PLANNING UNIT REPORT  
DEPARTMENT OF PLANNING AND DEVELOPMENT  
April 27, 2005

**ZONING MAP AMENDMENT/SUBDIVISION LOCATED AT 5501 PORTAGE ROAD  
(AMERICAN CENTER):**

DATE: April 22, 2005  
TO: Plan Commission  
FROM: Larry D. Nelson, P.E., City Engineer  
SUBJECT: 5501 Portage Road Rezoning

SUBJECT: **5501 Portage Road – Final Plat / Rezoning– The American Center Plat –  
Hanson Addition / O3 to O4**

**EXHIBIT C**  
**THE AMERICAN CENTER**  
**PRELIMINARY PLAT**  
**PROPOSED REZONING**

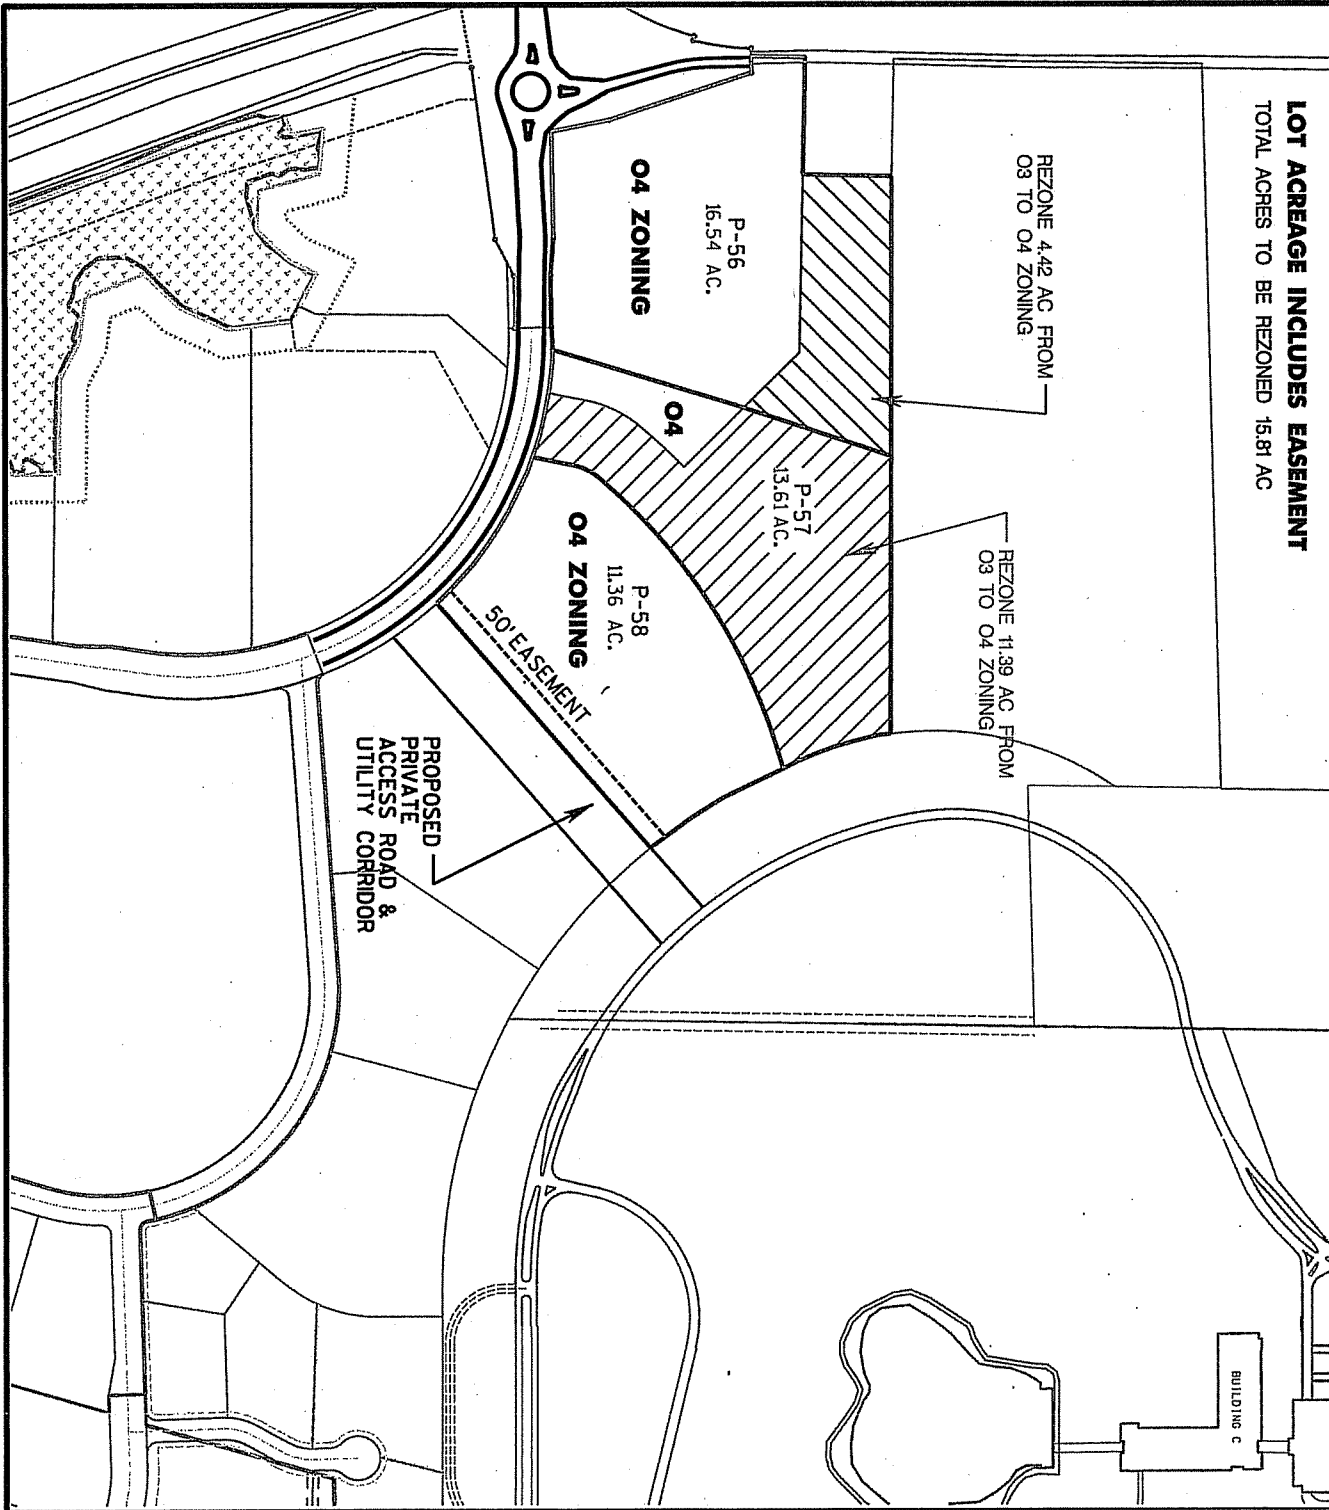
- 1. Portions of the area proposed for rezoning appear to be delineated environmental corridor and shall be so noted.
